Access Compliance Report

Public Rights-of-Way

(Curb Ramps)

Intersection ID: 16086	Main Street: HOLLIS_RD	Cross Street: WESTON_ST	Location: NE
ADA ID: AA4C59747319	Ramp Type: Directional1	Initial Pass/Fail: Fail	Overall Compliance: No
Severity Score: 12.5			
Codes/Mitigation Info/Possible Solution		Field Measurements/Component Compliance

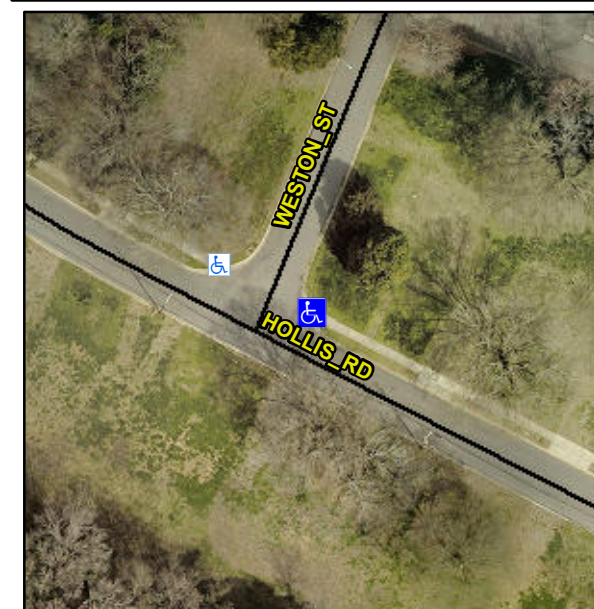
R304.5.3

Compliance	Description	Data	Compliance	Description	Data
N/A	Ramp Length (in)	52.0	N/A	Grade Break?	N/A
Yes	Ramp Width (in)	58.0	N/A	Grade Break Slope (%)	0.0
Yes	Ramp Slope (%)	1.7	N/A	Grade Break XSlope (%)	0.0
No	Ramp XSlope (%)	5.2			
N/A	Flare Type LT	N/A	N/A	Flare Type RT	N/A
N/A	Flare Slope LT (%)	N/A	N/A	Flare Slope RT (%)	0.0
N/A	Flare Traversable LT?	N/A	N/A	Flare Traversable RT?	N/A
N/A	Landing Length (in)	0.0	N/A	DWS Provided?	N/A
N/A	Landing Width (in)	0.0	N/A	DWS Contrast?	N/A
N/A	Landing Slope (%)	0.0	N/A	DWS Length (in)	N/A
N/A	Landing X Slope (%)	0.0	N/A	DWS Full Width?	N/A
N/A	Landing Curb? (Y/N)	N/A	N/A	DWS Offset LT (in)	N/A
N/A	Shared Landing?	N/A	N/A	DWS Offset RT (in)	N/A
N/A	Gutter Ponding?	0.0	N/A	Gutter Slope (%)	N/A
N/A	Gutter Lip Ht (in)	0.0	N/A	Gutter X Slope (%)	N/A
N/A	Painted X Walk1?	No		Road Slope (%)	4.4
	X Walk 1 Direction	To W		Road X Slope (%)	0.5
	X Walk 1 Width (in)	N/A		Clear Space?	N/A

Remove & Replace Entire Ramp.
